SUBJECT: Transmittal of Revised Responses to AP1000 DSER Open Items

**AP1000 Design Certification Review
Draft Safety Evaluation Report Open Item Non-Proprietary Responses**

DSER Open Item Number: 19.1.10.1-5 (Response Revision 1)

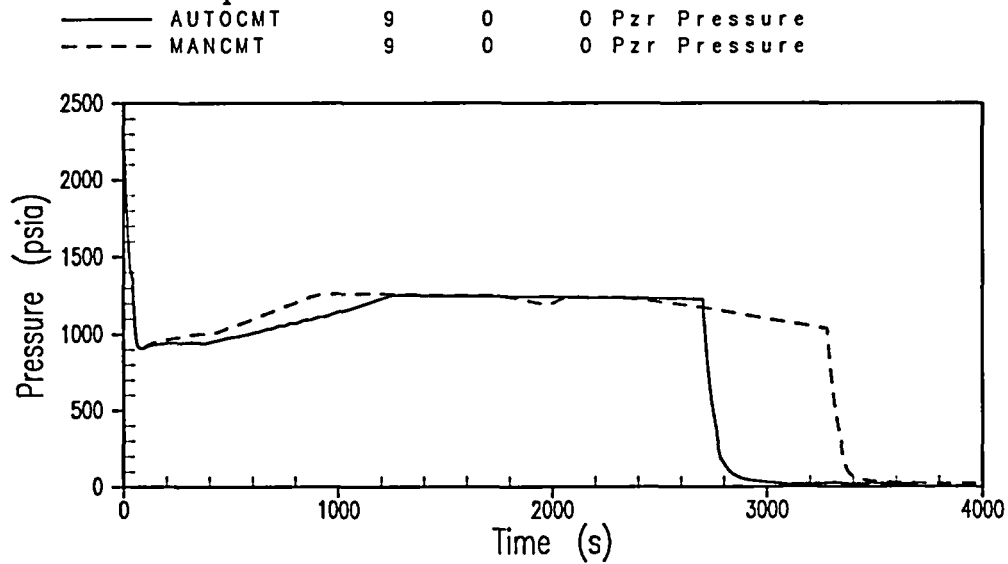
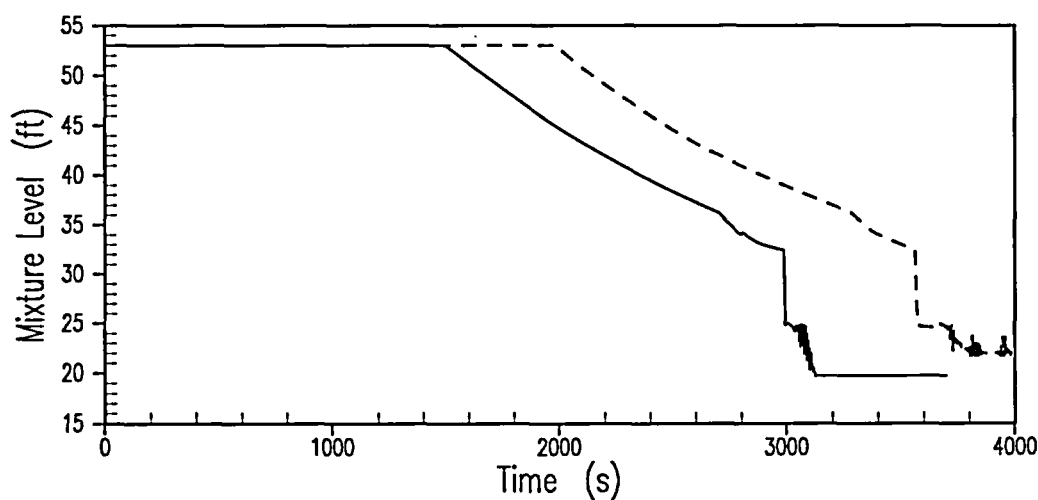
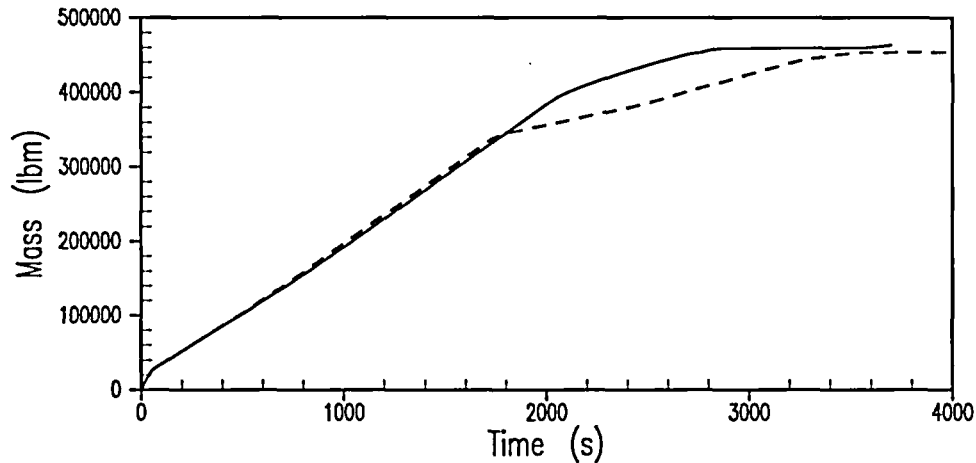
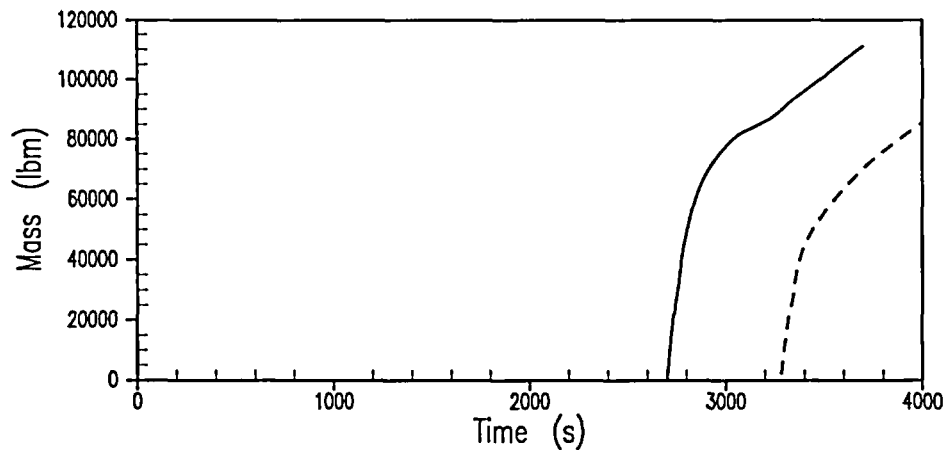
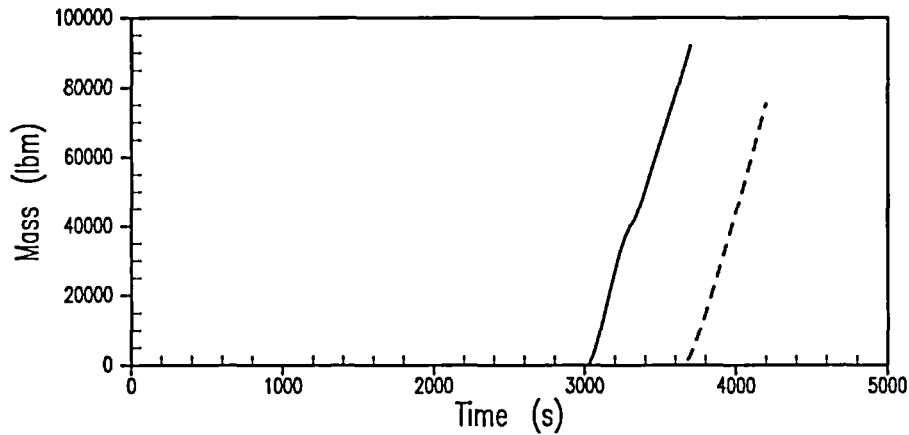
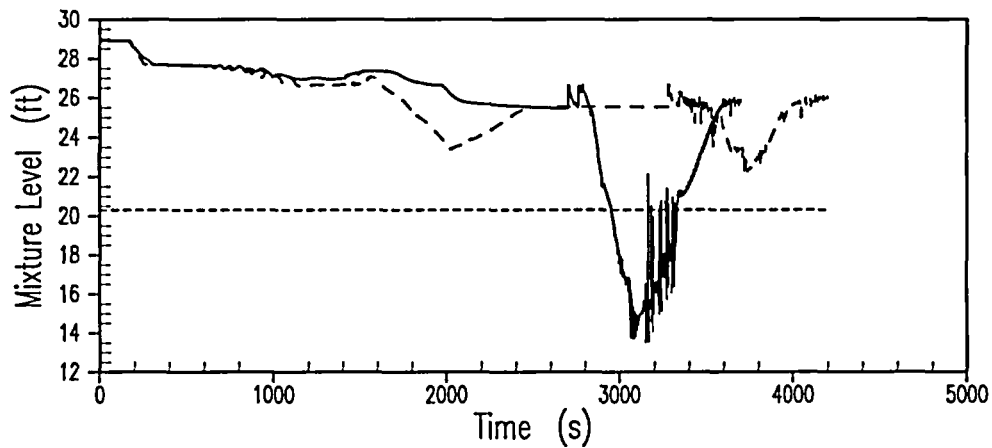
An analysis using MAAP4 was performed to demonstrate that a 30 minute delay in CMT injection is acceptable following a SBLOCA and multiple failures. The consequences were determined to be bounded by a MAAP4 analysis with automatic actuation. Westinghouse asserted that since this is not a limiting case a NOTRUMP analysis is not required. For the manual CMT case there is no ECCS for 2000 seconds after the break. For the automatic actuation case, CMT injection occurs about 200 seconds after the break. How can the automatic CMT actuation injection case be worse than the manual CMT actuation case which has a longer delay time?

- (e) The case in question (2 inch break, 1 CMT, 0 ACC, 0 ADS1-3, 0 PRHR, ¾ ADS4) has now been performed using NOTRUMP, for automatic CMT actuation and for manual CMT actuation. Comparison plots of these two NOTRUMP cases are shown in Figures 19.1.10.1-5e-1 through 19.1.10.1-5e-6. For the automatic CMT case the CMT draindown starts earlier and leads to earlier actuation of ADS4. For the automatic case the CMT recirculates from the early part of the event and its water inventory becomes heated before draindown begins, whereas for the manual case CMT draindown occurs shortly after CMT actuation and therefore is injecting subcooled liquid during its draindown. When ADS4 actuation occurs in the automatic case the vessel inventory and CMT injection are near saturation and the rapid depressurization results in sufficient voiding to cause the vessel mixture level to fall into the core region before it recovers as a result of IRWST injection. In the manual case the CMT injection just prior to and following ADS4 actuation is still highly

subcooled so the depressurization causes less voiding and the vessel mixture remains in the upper plenum region during the ADS4 to IRWST transition.

These NOTRUMP results confirm the behavior seen in the previous MAAP4 analyses.

Figure 19.1.10.1-5g-1

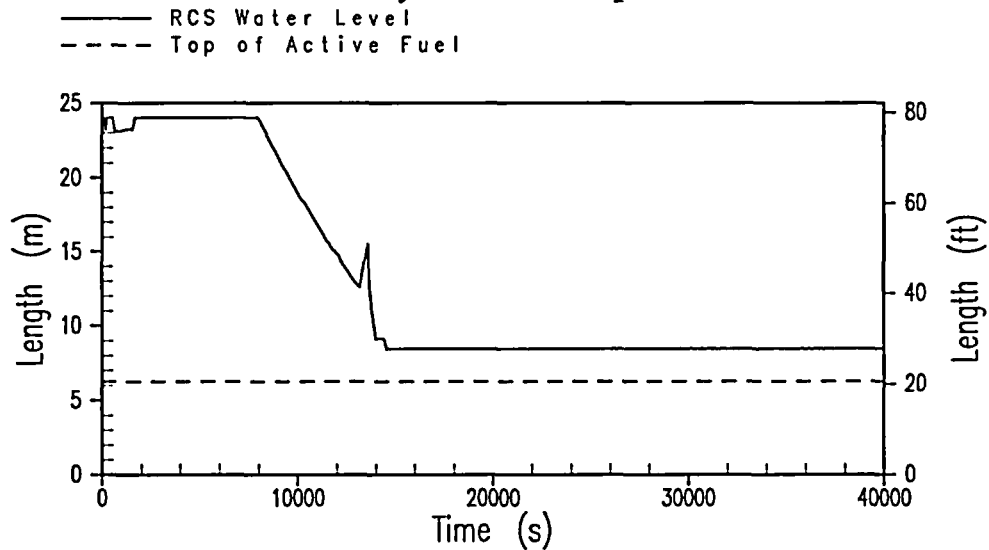
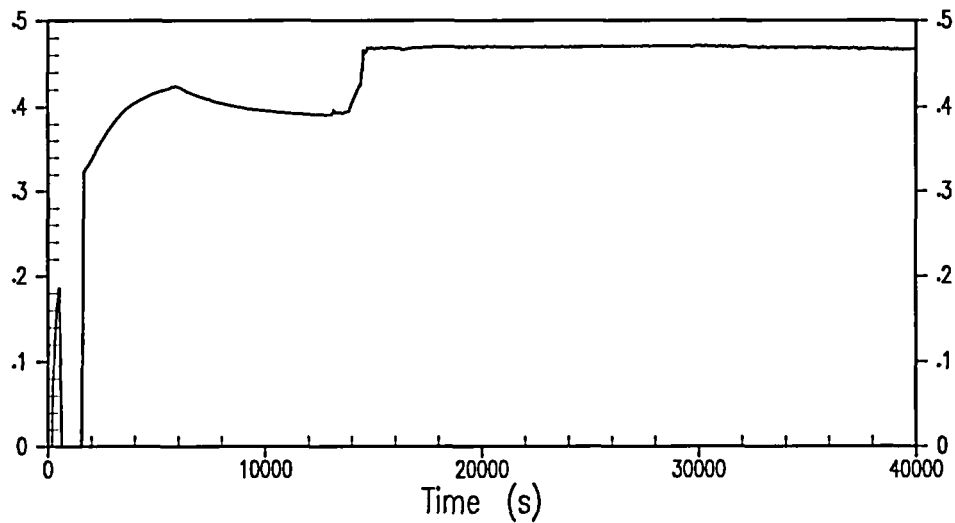
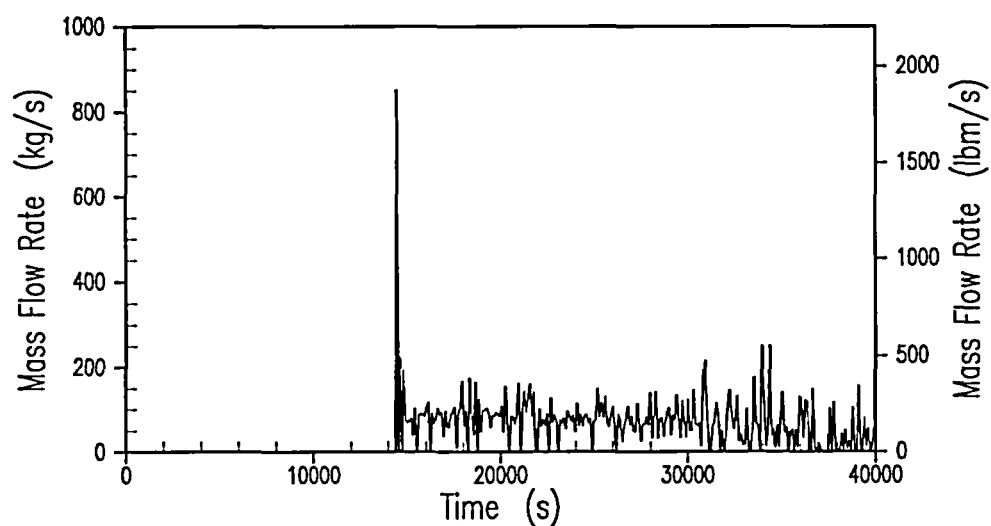
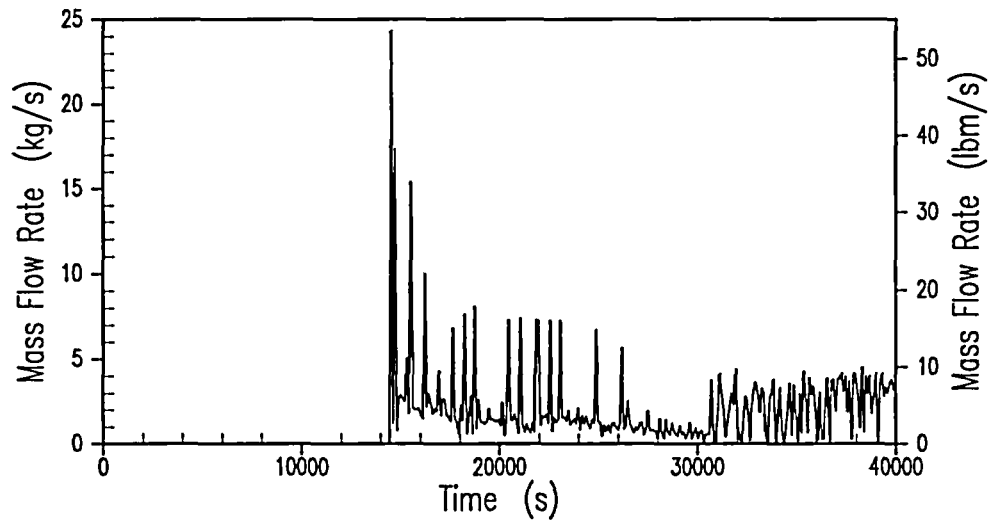
In its response to the staff RAI 440.043 regarding the AP1000 design features that mitigate or prevent steam generator safety valves challenges during an event of rupture of multiple steam generator tubes (MSGTR), Westinghouse provided a beyond-design-basis analysis of MSGTR using MAAP4. Two cases were analyzed: a passive system mitigation case with PRHR heat exchanger operation; and a minimum PRHR heat removal case with the assumption of steam generator safety valve (SGSV) failed open. Based on the MAAP4 analysis, Westinghouse concluded that for the MSGTR, the core remains covered and

cooled, and thus no significant fission product release occurs. In DSER Section 5.4.2.3.2, the staff stated that the staff's evaluation of the use of MAAP4 for the AP1000 PRA evaluation is discussed in Chapter 19 of DSER. In DSER Chapter 19 the staff gave conditions for the use of MAAP4 as described in the above excerpt.

In light of Open Item 19.1.10.1-5 and the concern described in the DSER that MAAP4 does not provide a rigorous solution of reactor system conditions during transients and accidents, the staff requests that Westinghouse confirm the beyond-design-basis MSGTR results of no core uncover described in response to RAI 440.043 with a methodology reviewed by the staff.

- (g) As discussed with the NRC in the teleconference, the use of the MAAP4 code for AP1000 is the same as was approved for AP600. Westinghouse uses MAAP4 to perform analyses of accident sequences from the PRA. For those cases with large margin (i.e. little or no core uncover), the MAAP4 results are used to validate the PRA success criteria. For low margin success sequences that are also high risk, Westinghouse performs additional analyses with the approved design basis analysis computer codes to demonstrate success.

For both AP600 and AP1000, Westinghouse has submitted results of the analysis of a multiple steam generator tube rupture. For both AP600 and AP1000, there is a large margin to core uncover, and the results have been accepted for the purpose of demonstrating the plant response to this beyond design basis accident. The previous analysis results provided for AP1000 did not identify the top of the active fuel, and the staff was unable to assess the large margin in the analysis results. The attached figures 19.1.10.1-5g-1 through 4 show the results of the multiple steam generator tube rupture for AP1000. The MAAP4 code is applied appropriately for this large margin case.
